CITY OF NAPOLEON - BUILDING DEPARTMENT
 255 West Riverview Avenue, Napoleon, Ohio 43545 - 419-592-4010

Size: Length 16' Width 14' Stories 1 Ground Floor Area 224 S.F.
 Height 13' Building Volume (for demo. permit) _____ cu. ft.
 Electrical: Relocate entrance & 4 circuits brief description
 Plumbing: N.A. brief description
 Mechanical: N.A. brief description
 Sign: N.A. Dimensions _____ Sign Area _____
 Additional Information: Covered porch addition.

RESIDENTIAL PLAN CORRECTION SHEET

ADDENDUM TO Permit No. 01361-(1)
Owner JIM HERSHBERGER
Contractor WILLIAM LAWLER
Location 929 HALEY

WEST WALL SECTION

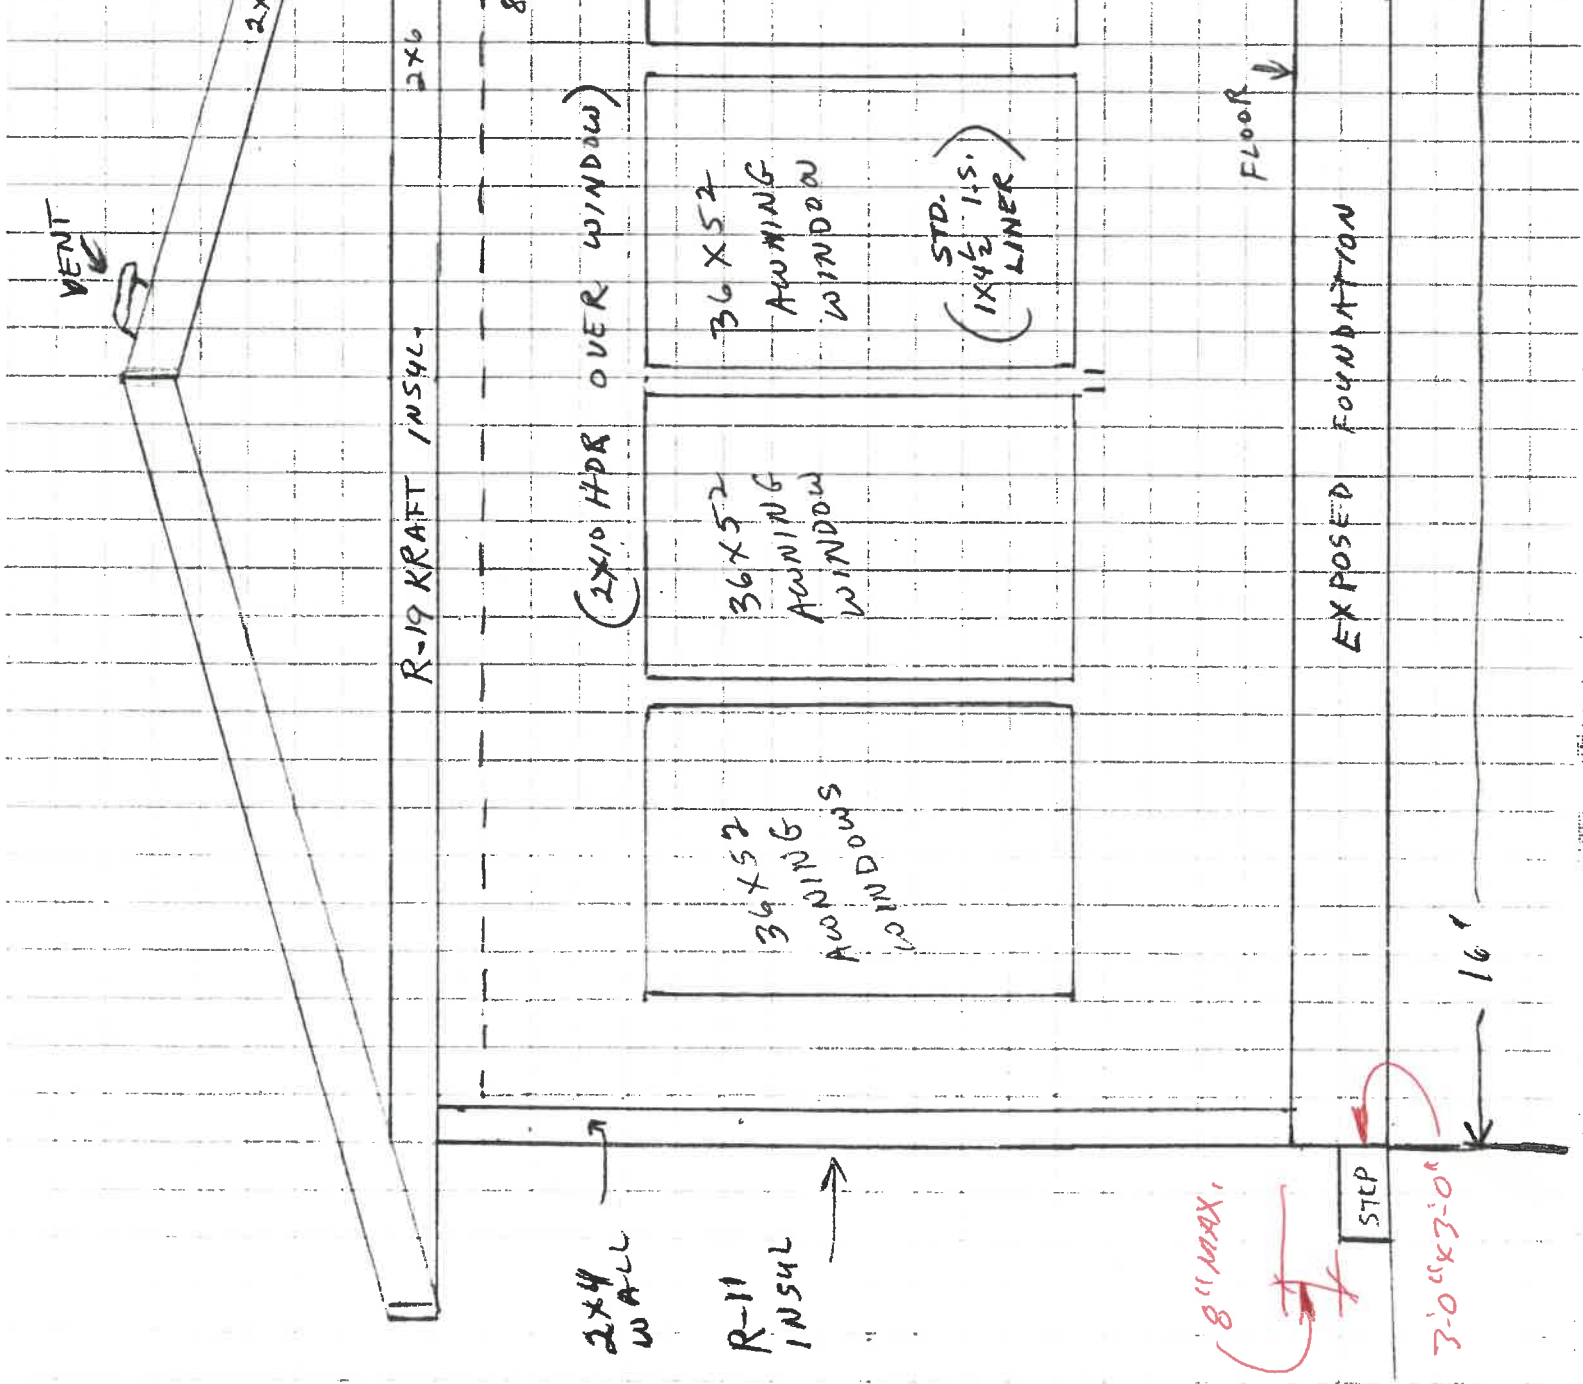
Additional Corrections: "A" PROVIDE MIN 1x4 OR LARGER RAFTERS FROM RIDGE TO CEILING JOISTS TO CUT THE ALLOW SPAN TO 8'-0" FOR THE 2x6 CEILING JOISTS
